MODIFICATION PROCEDURE

NOTICE NO. N-81
DATE Nov. 9, 1970
PAGE 4 of 6

FIGURE 1. KING RADIO ELECTRICAL WIRING DIAGRAM.

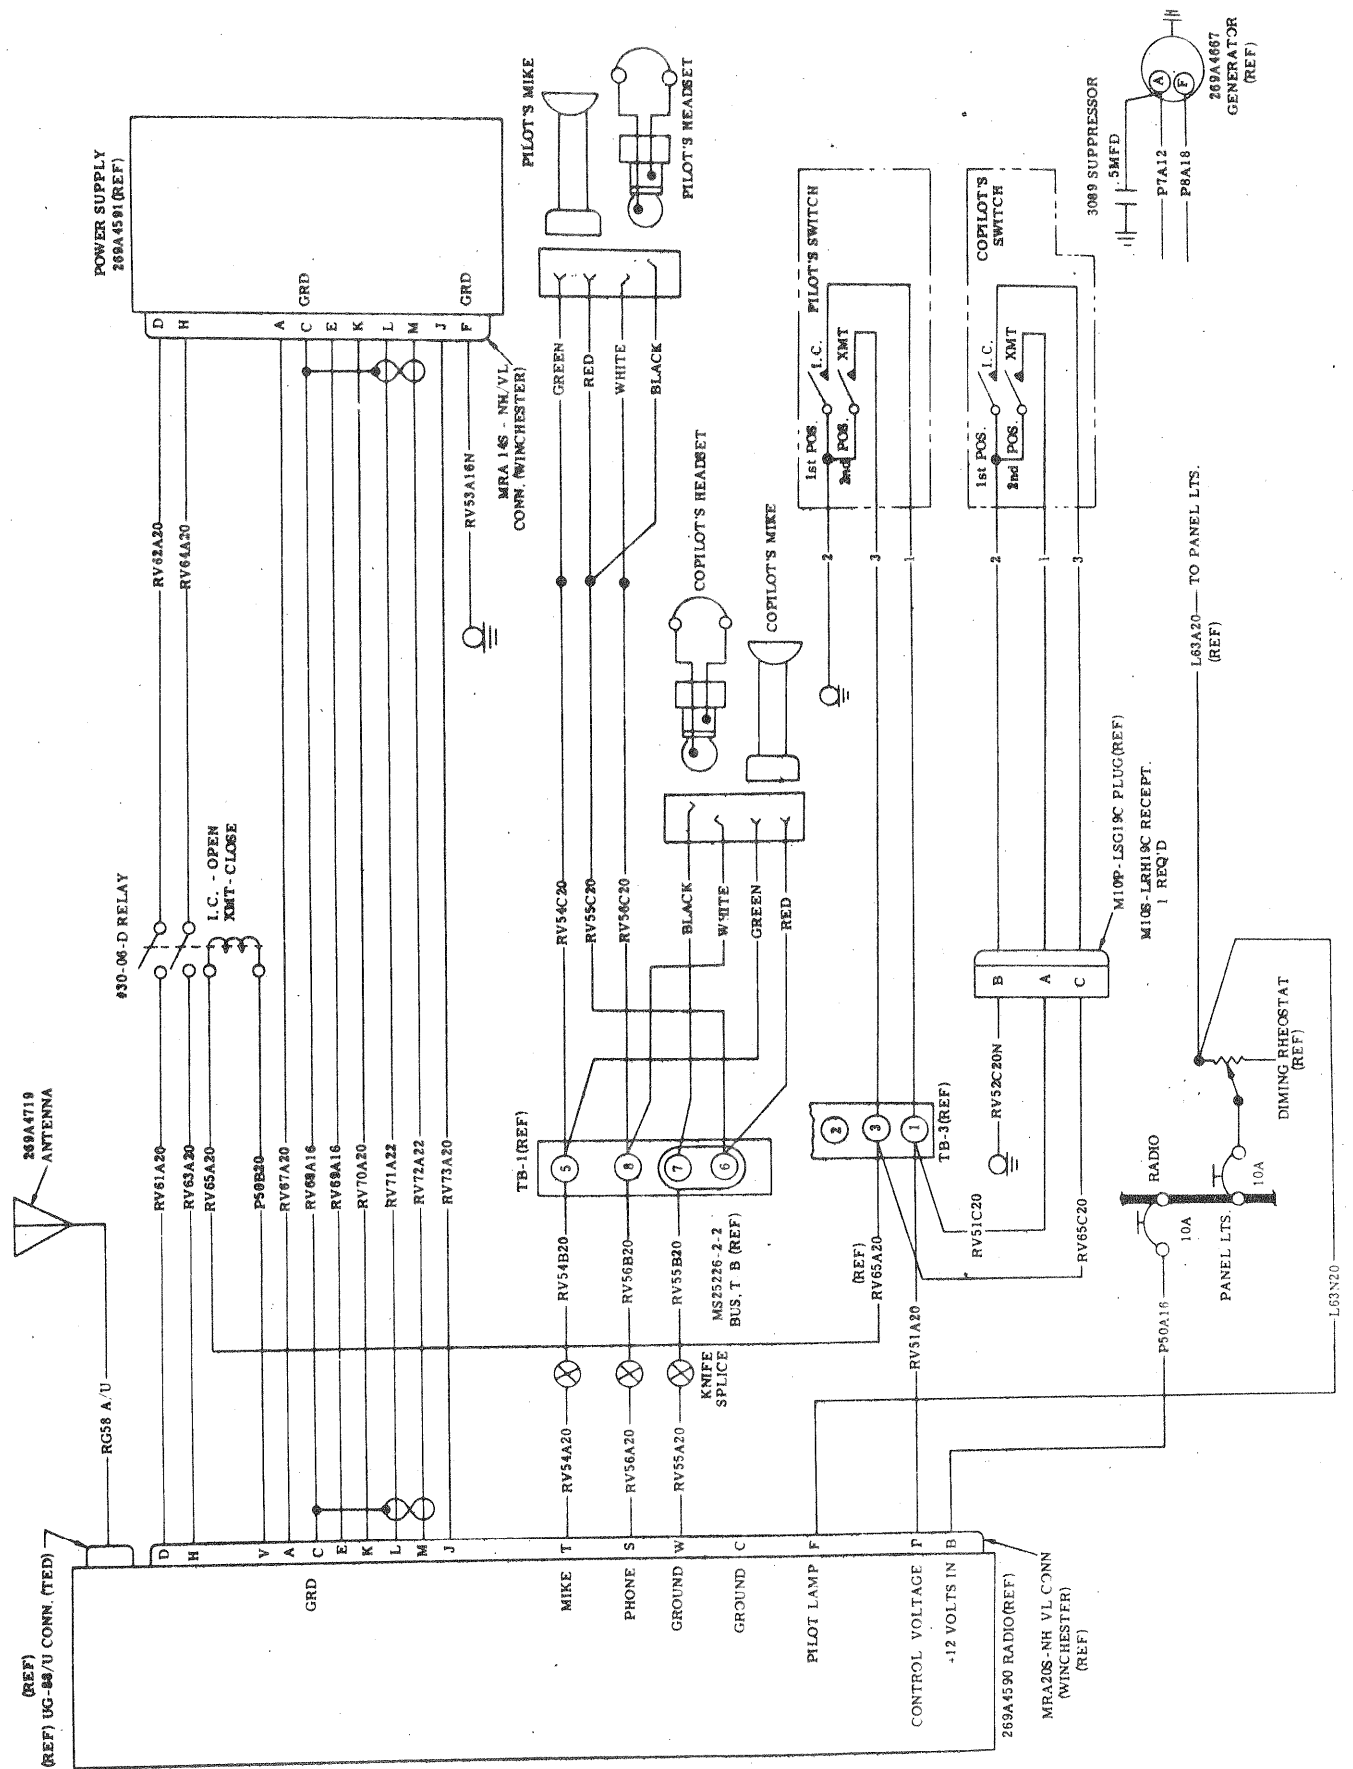
- f. Remove lower forward fairing; cover engine air intake opening.
- g. Remove transceiver radio from casing.
- i. Remove existing wire nos. RV61A20 and RV62A20 from #30-06-D relay and splice together. (See figures 1 and 2)

- j. Remove existing wire nos. RV63A20 and RV64A20 from relay and splice together.
- k. Solder two short pieces of insulated wire (about one inch long) to the back side of pins M and F at the amp/power supply connector (MRA 14S-NH/VL). Trim the wires as short as possible allowing only enough to permit soldering of a 200 mfd 25 vdc capacitor between them with the plus side at M. Tie capacitor to wire bundle and protect leads with insulated sleeving.

m. Remove existing splice from wire no. RV54A20 (from terminal T of tuner); connect wire to N.C. contact of #30-06-D relay, using #31882 terminal lug.

n. Remove existing splice from wire no. RV54B20 (from terminal 5 of terminal board TB-1); connect wire to N.C. contact of relay, using #31882 terminal lug.

1. Remove existing wire no. RV51A20 from terminal 1 of terminal board TB-3; remove existing wire no. RV65A20 from terminal 3 of TB-3.
2. Reverse connect above wires, so that wire no. RV51A20 connects to terminal 3 of TB-3, and wire no. RV65A20 connects to terminal 1 of TB-3.

1. Remove existing wire no. RV51C20 from terminal 1 of terminal board TB-3; remove existing wire no. RV65C20 from terminal 3 of TB-3.
2. Reverse connect above wires, so that wire no. RV51C20 connects to terminal 3 of TB-3, and wire no. RV65C20 connects to terminal 1 of TB-3.
